**Rules for the Survey and Construction of Steel Ships**  
**Part CSR-B&T** **2016 AMENDMENT NO.2**

Rule No.82 27th December 2016

**AMENDMENT TO THE RULES FOR THE SURVEY AND CONSTRUCTION OF STEEL SHIPS**

**Part CSR-B&T COMMON STRUCTURAL RULES FOR BULK CARRIERS AND OIL TANKERS**

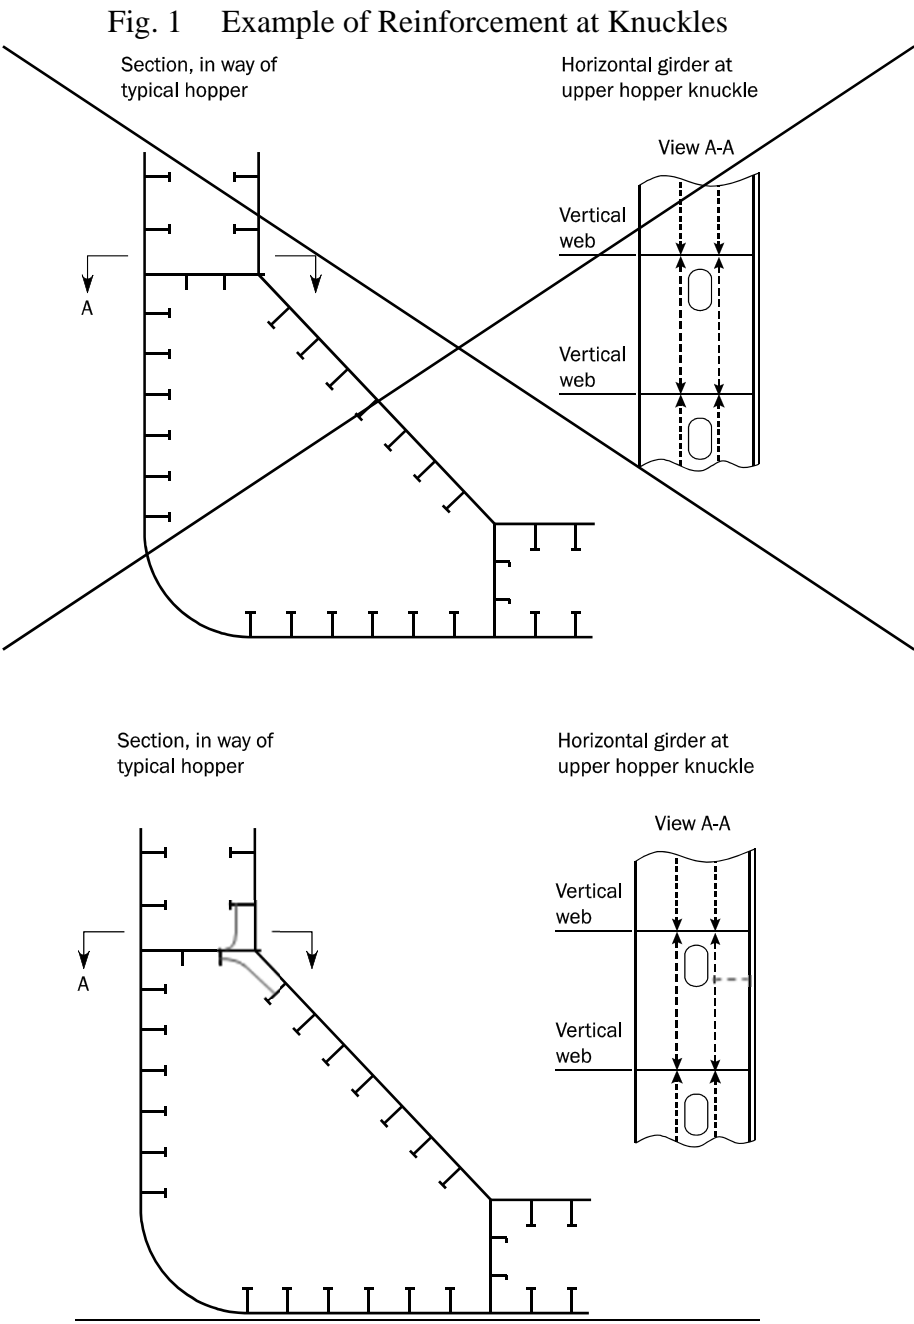
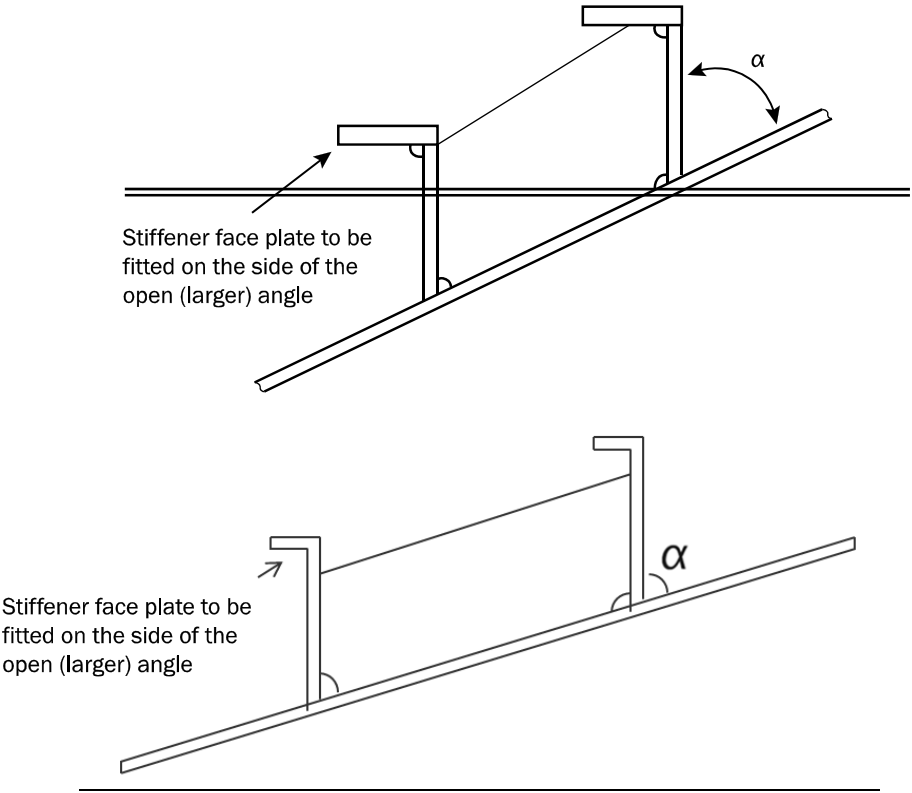
Fig. 1 has been amended as follows.

Fig. 8 Symmetric and Asymmetric Cut-outs

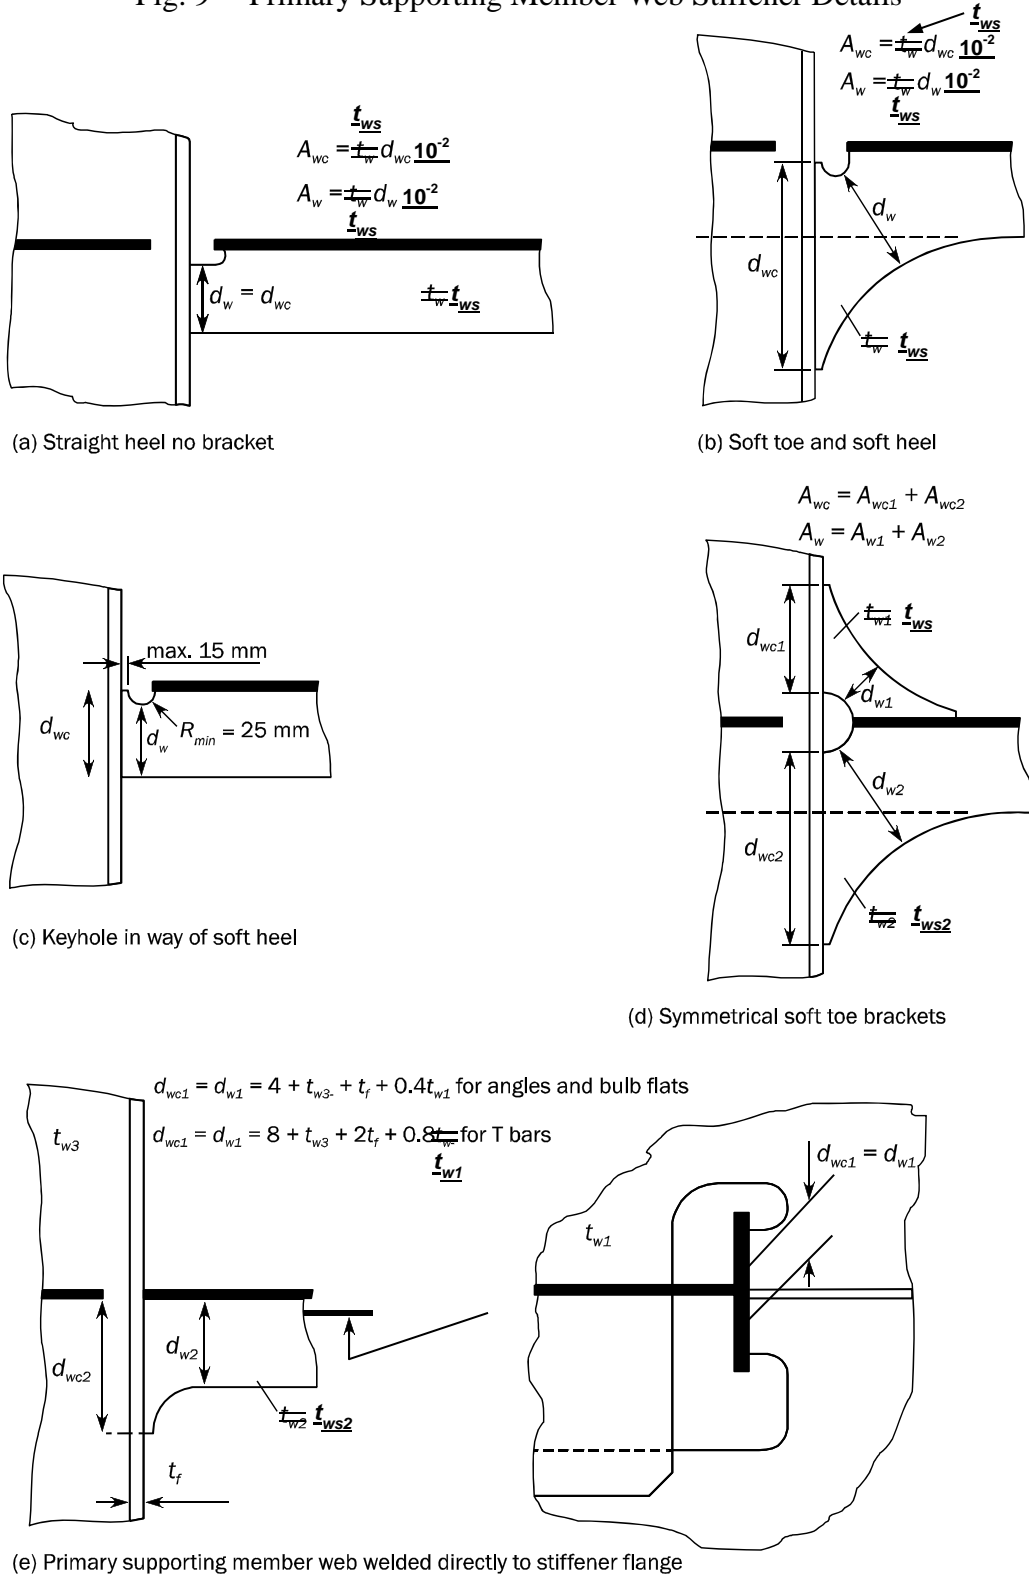
Fig. 8(e) has been amended as follows.

(e) Lug or collar plate and direct connection

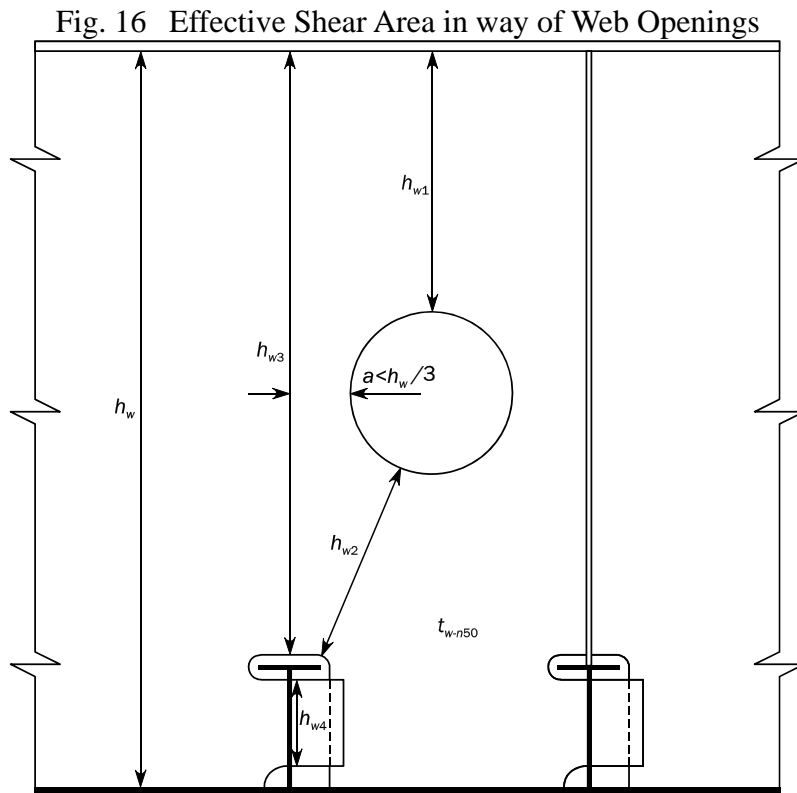
Paragraph 1.4.8 has been amended as follows.

The effective web height,  $h_{eff}$ , in *mm*, to be considered for calculating the effective net shear area,  $A_{sh-n50}$  is to be taken as the lesser of the following, where the third formula is only taken into account for an opening located at a distance less than  $h_w/3$  from the cross-section considered. ‡

$h_{w1}$ ,  $h_{w2}$ ,  $h_{w3}$ ,  $h_{w4}$ : Dimensions as shown in **Fig. 16**.

Fig. 5    Longitudinal Plates for Single Hull Bulk Carrier

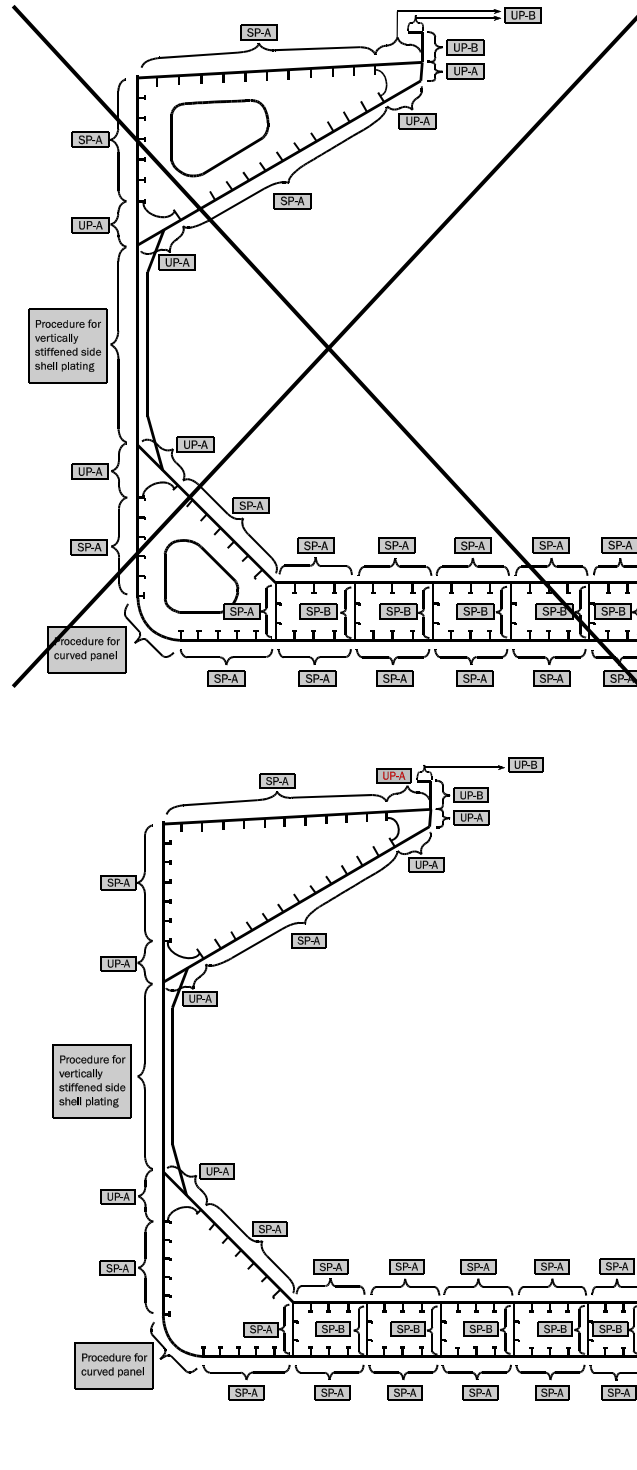
Fig. 5 has been amended as follows.

Fig. 7 Longitudinal Plates for Double Hull Bulk Carrier

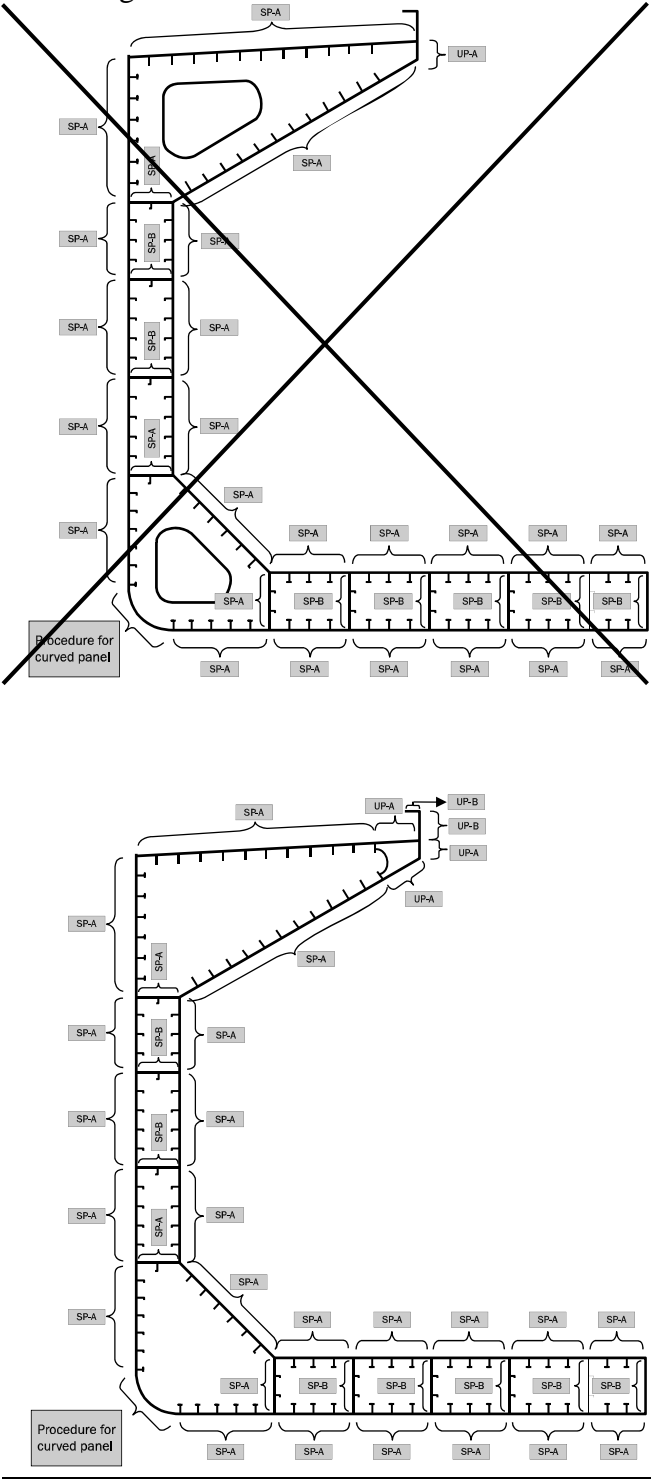
Fig. 7 has been amended as follows.

Table 6 Reduction Factors

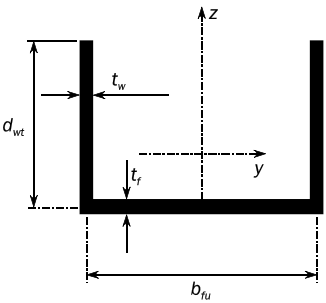
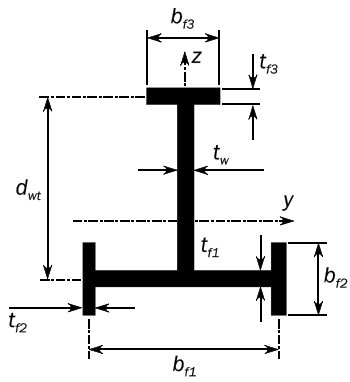
Table 6 has been amended as follows.

Configuration	$C_x, C_y$	$C_\tau$	
		Opening modelled in PSM	Opening not modelled in PSM
(omitted)			
<p>(c) Example of hole in web:</p> 		<p>Panels <math>P1</math> and <math>P2</math> are to be evaluated in accordance with (a). Panel <math>P3</math> is to be evaluated in accordance with (b).</p>

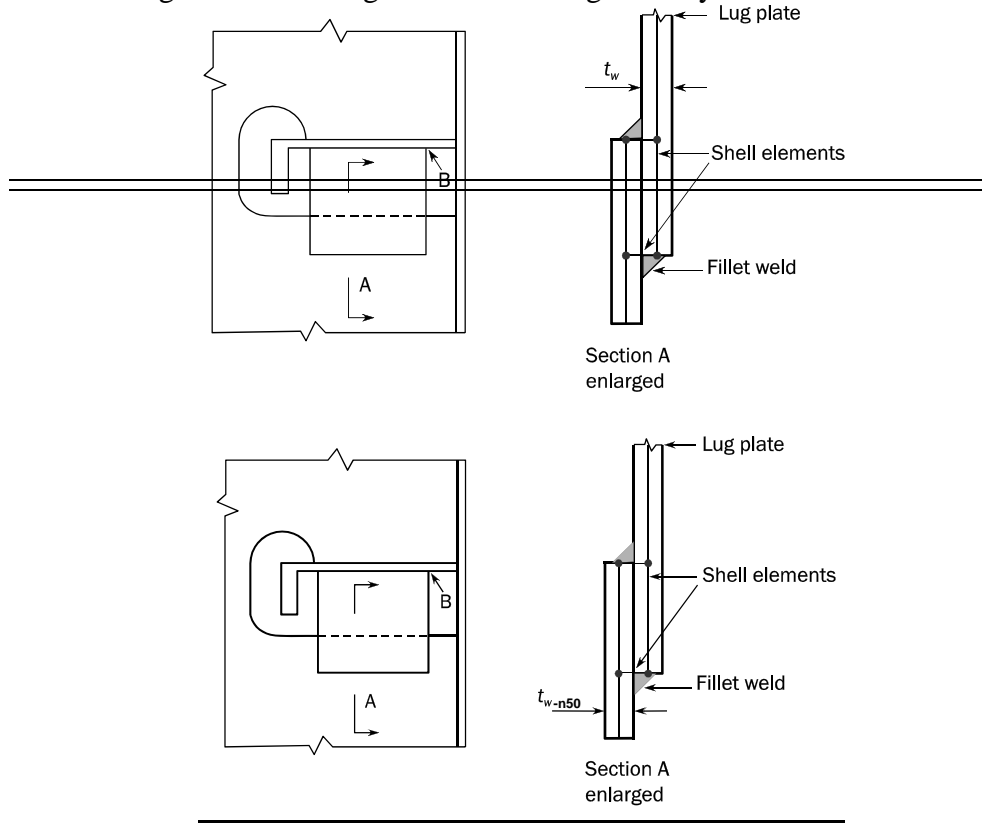
Paragraph 3.3.2 has been amended as follows.

The procedure for calculation of hot spot stress at flange such as inner bottom /hopper sloping plate is the same that for web-stiffened cruciform joints as described in **4.2.1**. The procedure that applies for hot spots on the ballast tank side of the inner bottom/hopper plate in way of a bent hopper knuckle is in ~~principal~~ principle the same as that applied on the cargo tank side of the inner bottom plate for welded knuckle in **Fig. 18** and **Fig. 19**. The intersection line is taken at the mid-thickness of the joint assuming median alignment. The plate angle correction factor and the reduction of bending stress as applied for a web-stiffened cruciform joint in **4.2.2** are not to be applied for the bent hopper knuckle type.
